November 21, 2018

Certificate of Appropriateness Application
BAR 18-11-03
1415 University Avenue
Tax Parcel 090075000
Tiger Investments, LLC, Owner
OTJ Architects, Applicant
Exterior Renovations

**CITY OF CHARLOTTESVILLE
BOARD OF ARCHITECTURAL REVIEW
STAFF REPORT
November 20, 2018**

Exterior Renovations

BUILDING FRONT ELEVATION

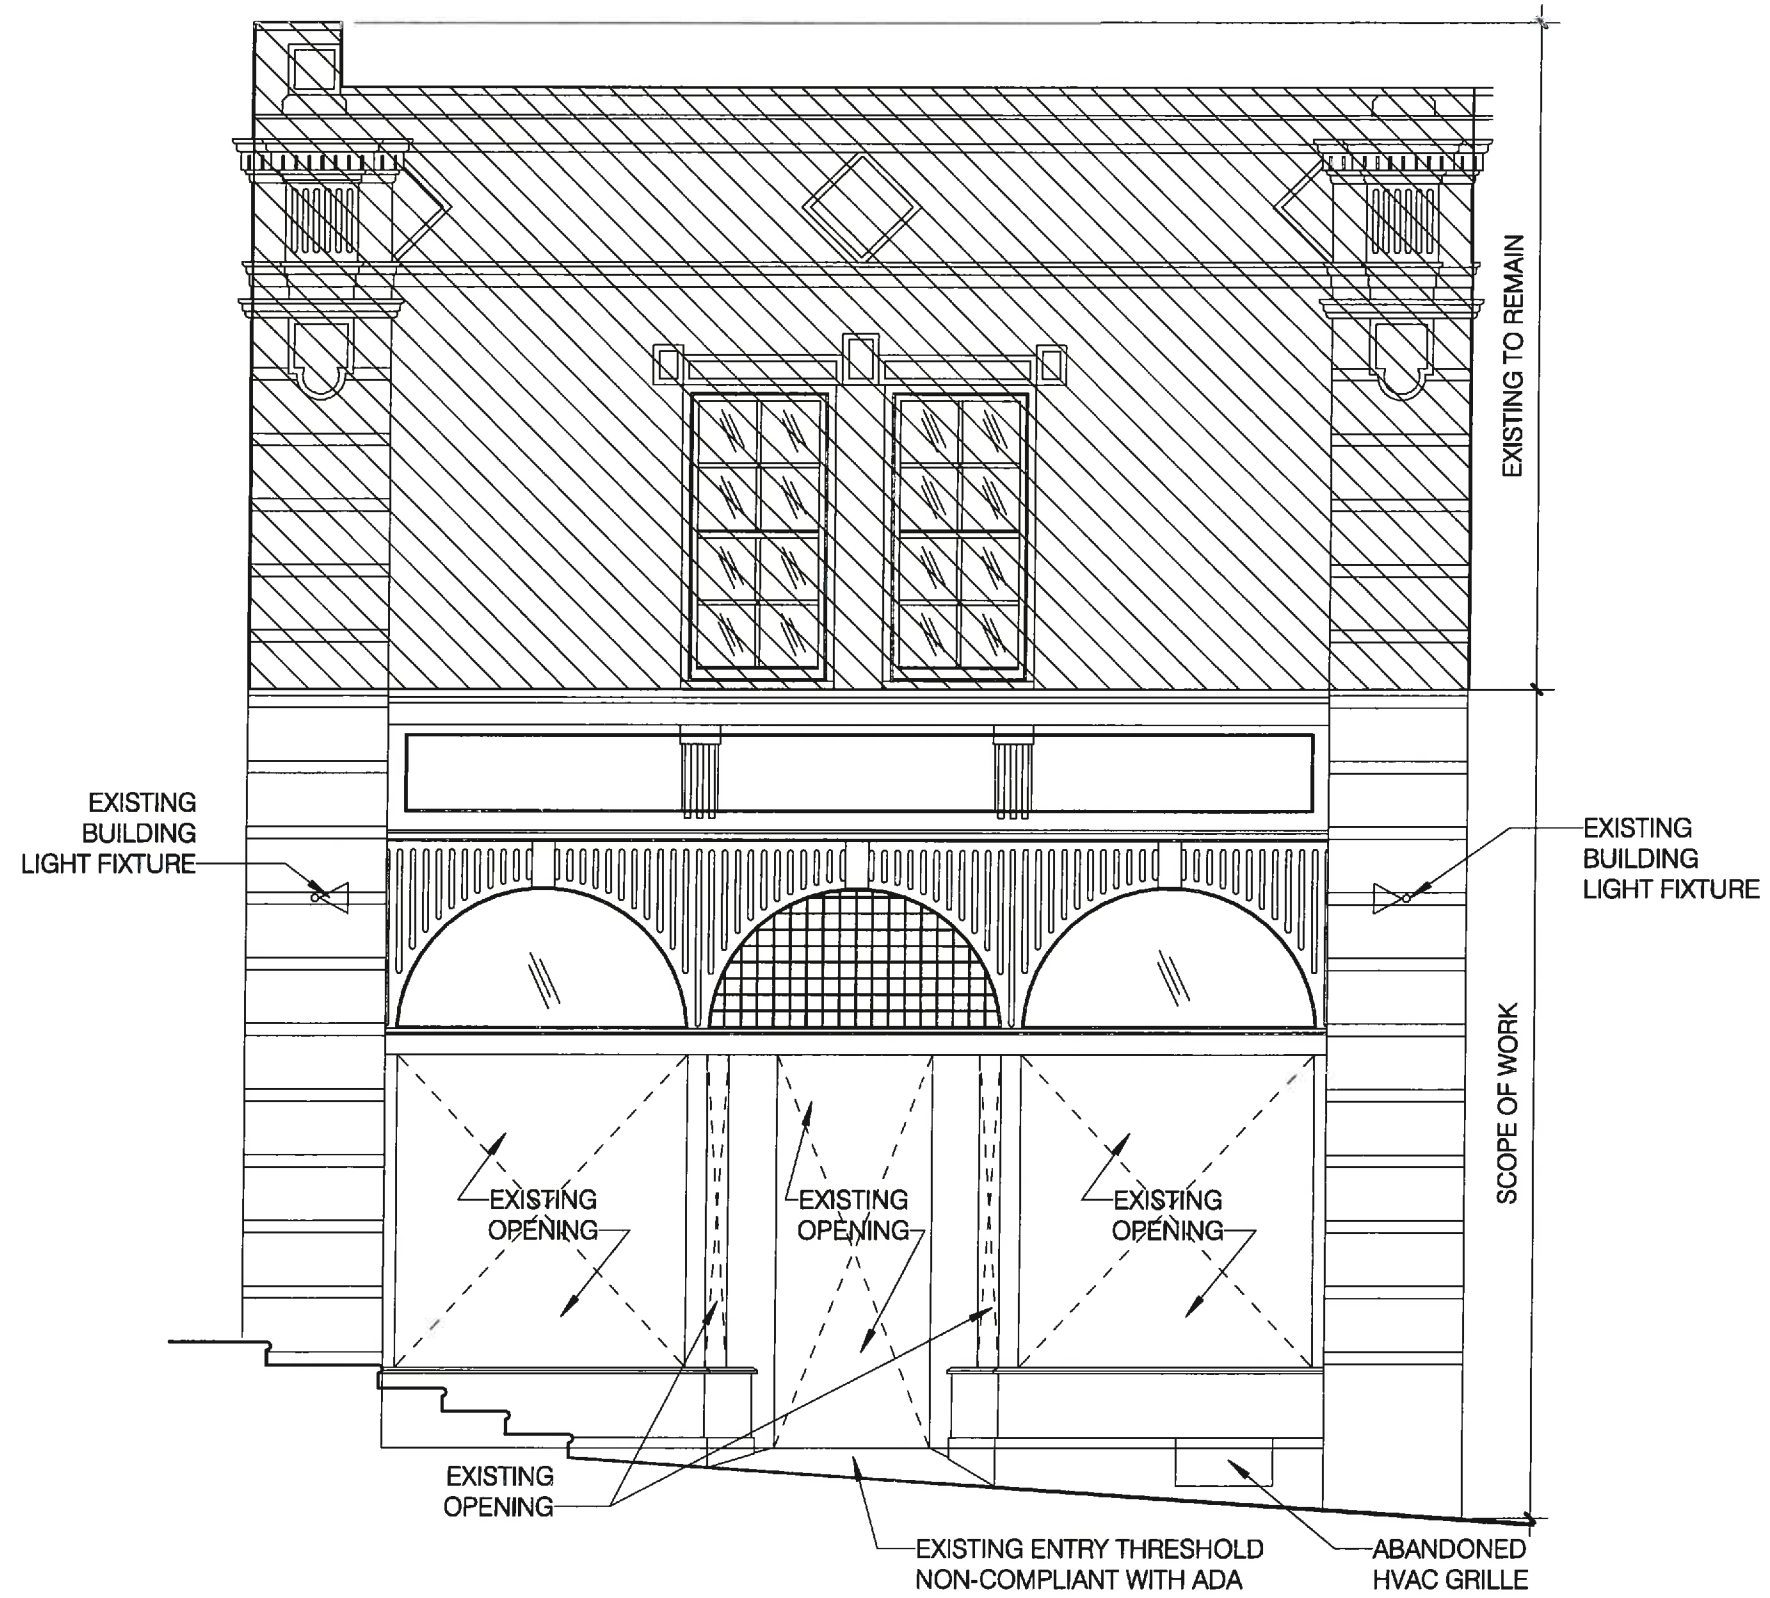
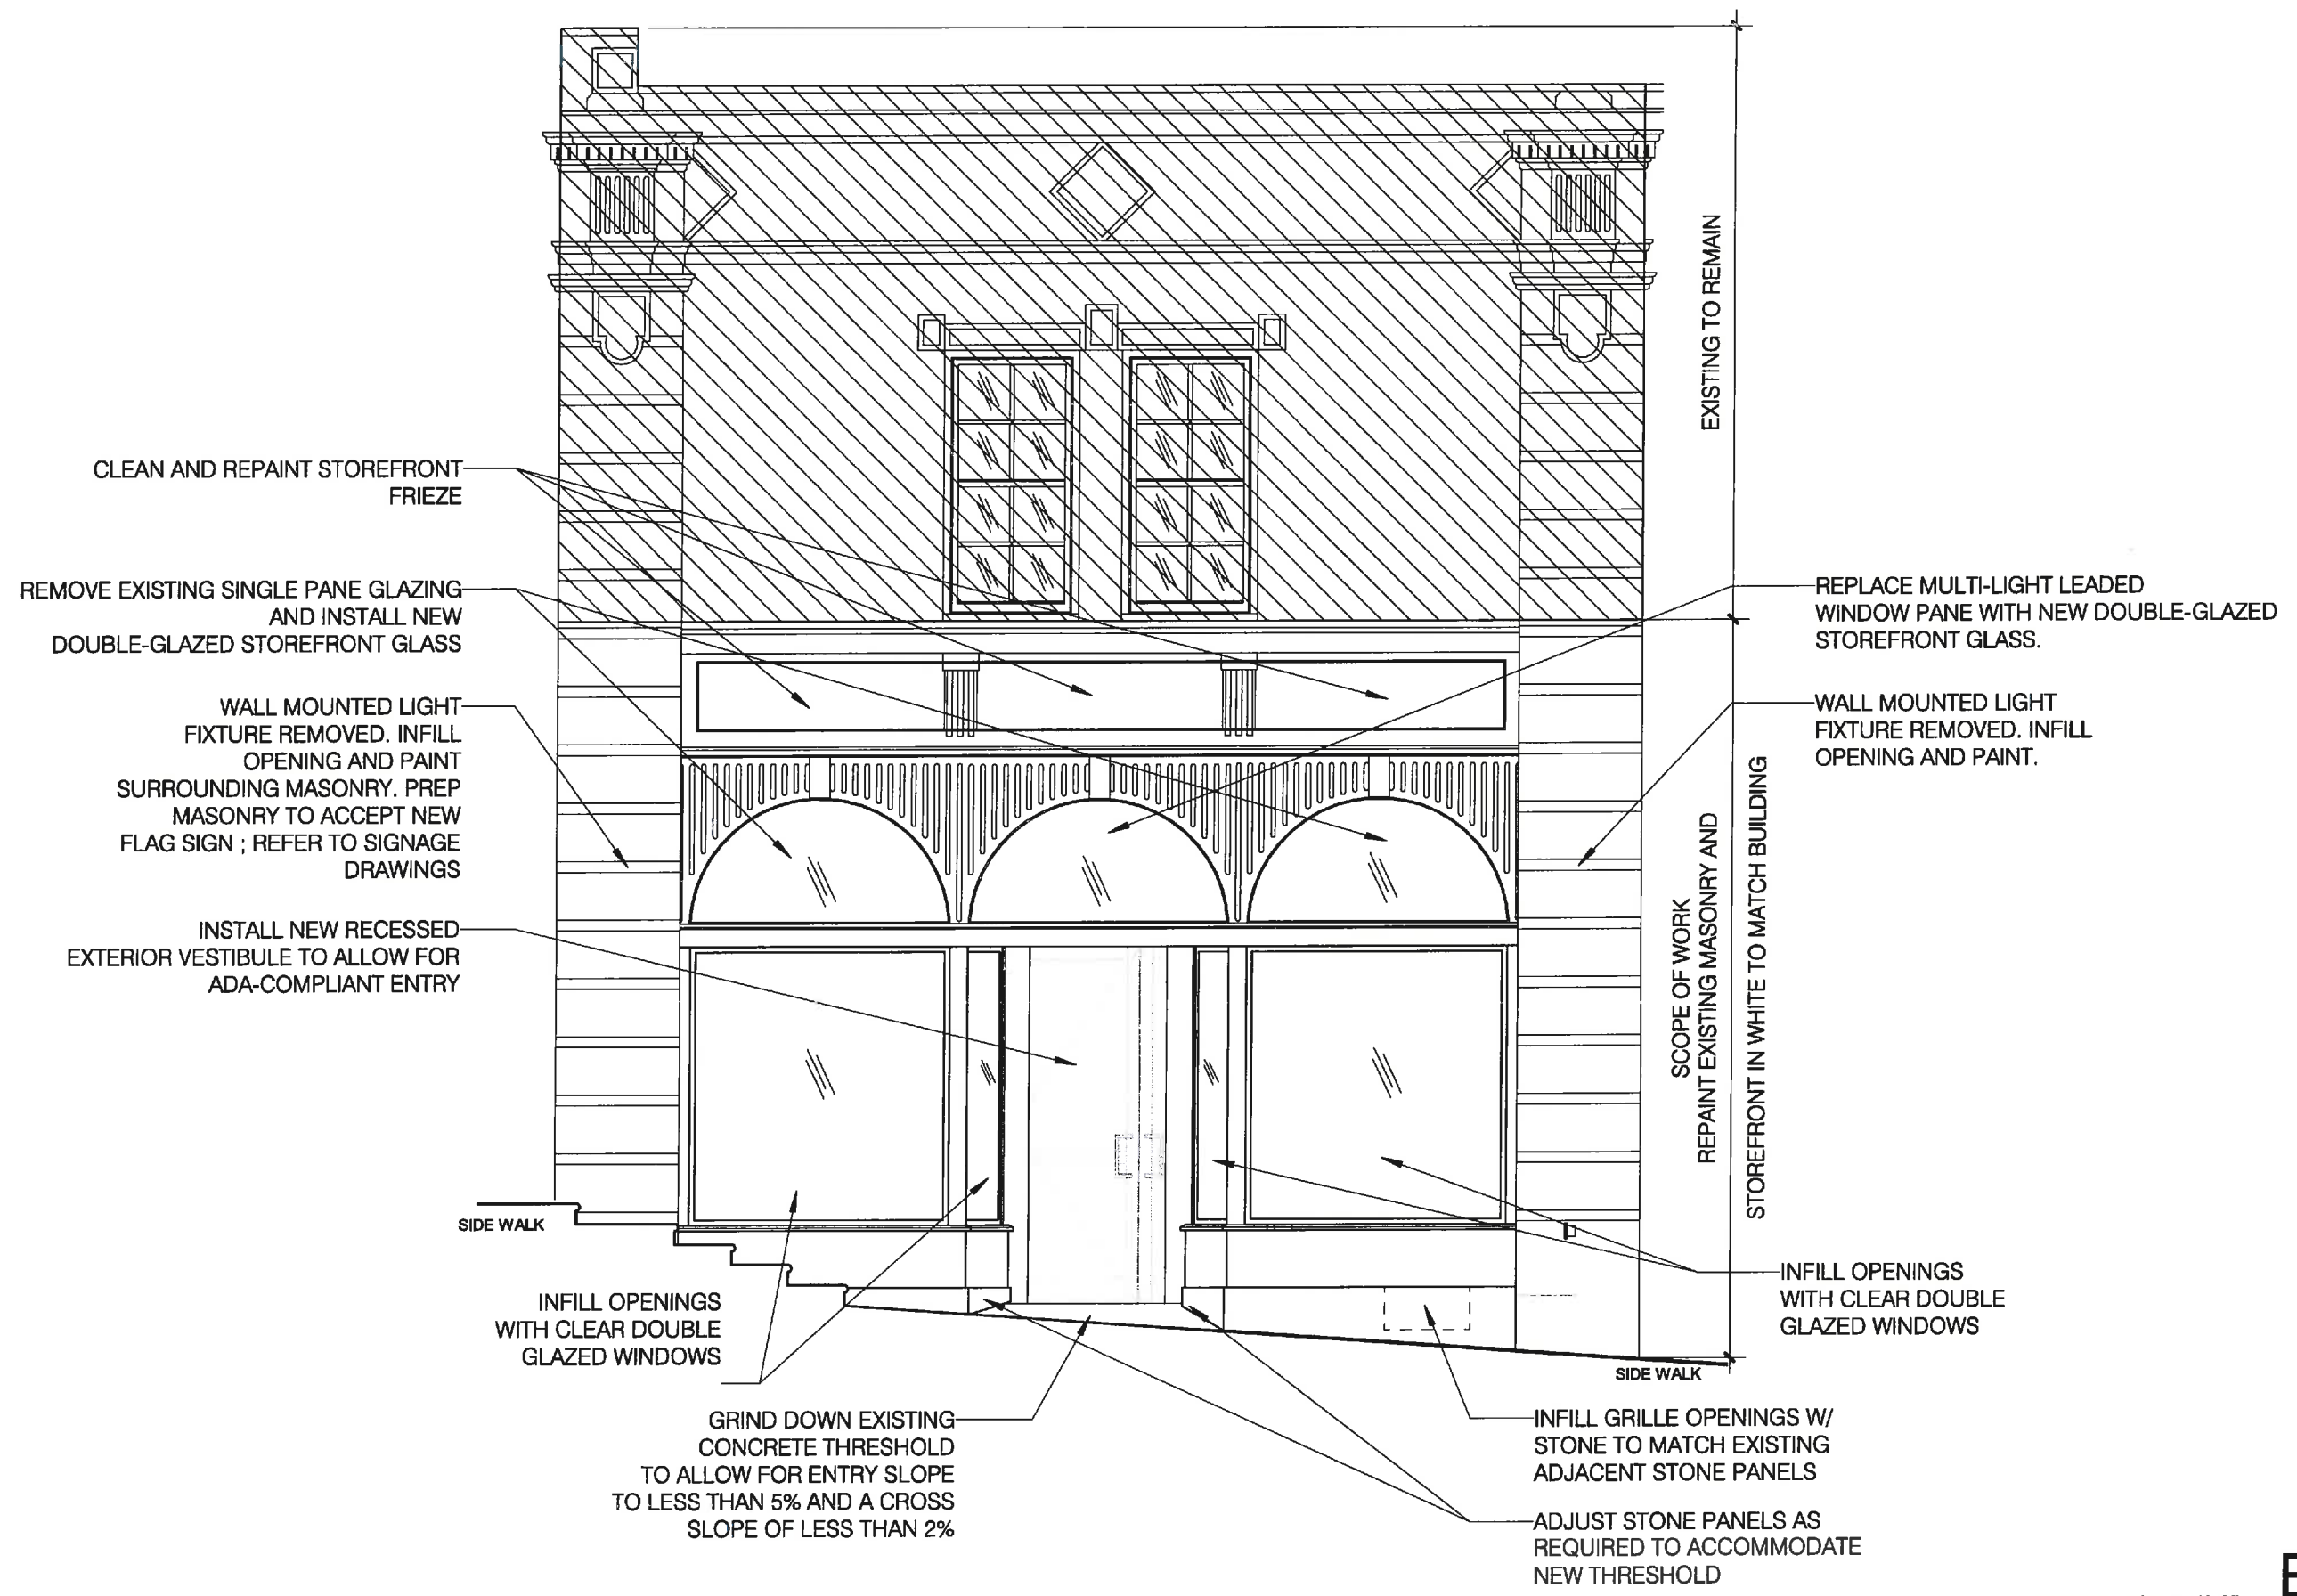
- BAR does not approve the removal of the leaded glass window
- BAR strongly recommends you revisit the double door, investigate a single door [at entry foyer]

Regarding the leaded glass, staff recommends a careful and deliberate discussion prior to a decision. The applicant has concluded that the panel is in poor condition and should be removed. (If removed, the intent is to display it inside the new space.) Staff informed the applicant that the ADC Guidelines recommend rehabilitation over replacement and call for a thorough survey of the existing conditions. Should the BAR determine that this matter requires additional information or evaluation, in lieu of deferring the application, staff recommends approval of the COA exclusive of a decision on the leaded glass panel.

CUST-F-6
Non-ILLUMINATED FLAG SIGN
SCALE: NTS

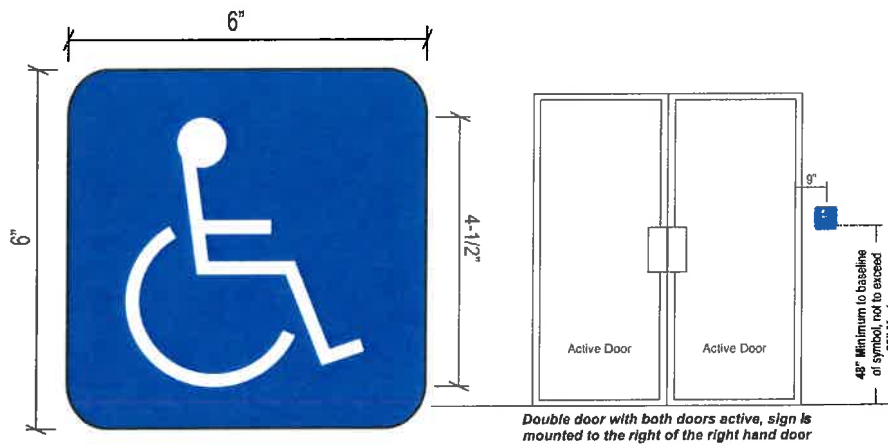
The BAR review is for the concept only, as signs require a separate sign permit. The proposed projecting sign complies with the Guidelines and staff recommends approval with the condition that any anchoring into the masonry wall be placed into the mortar joint, not into the brick.

...that any anchoring into the masonry wall be placed into the mortar joint, not into the brick

FLT-OCT-3
ILLUMINATED HANGING FLAT OCTAGON - INTERIOR
SCALE: NTS

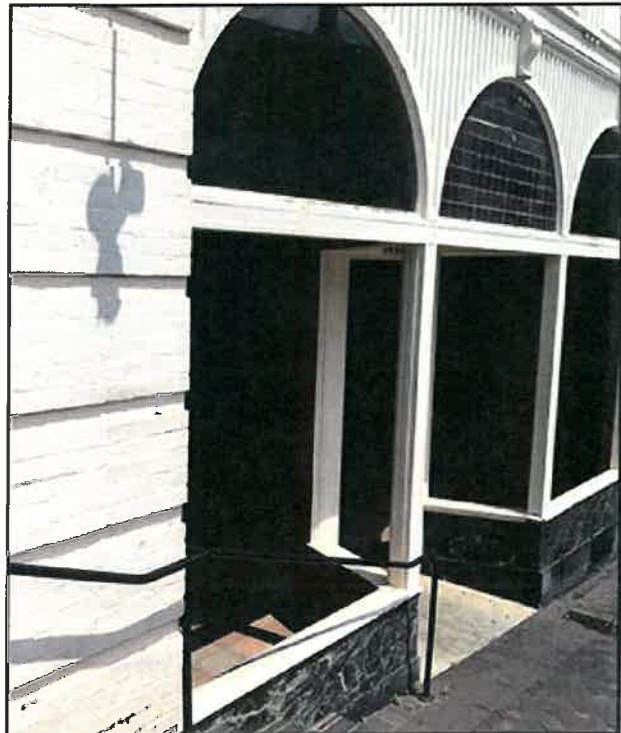
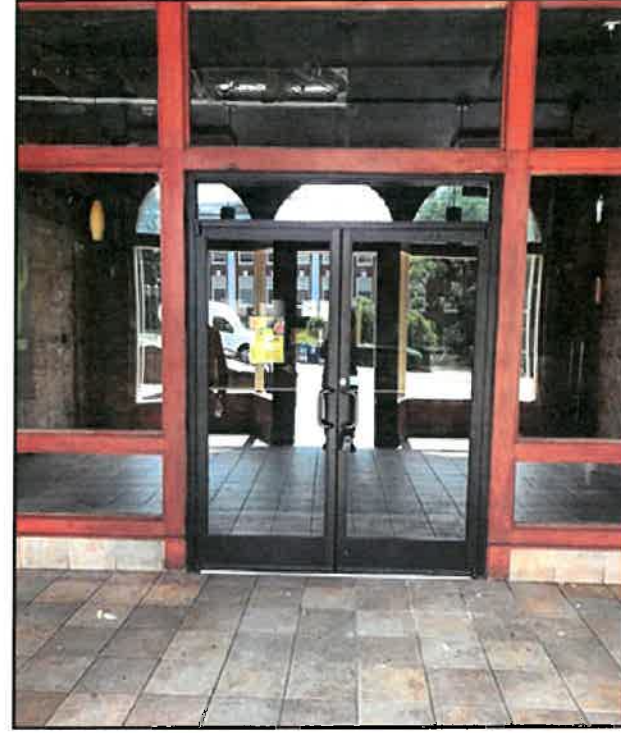
The two interior signs, while not regulated and do not require sign permits, will be visually prominent and should be discussed by the BAR. (Staff will review this matter with zoning staff and bring to the meeting a recommendation on what, if any, actions may be available to the BAR.)
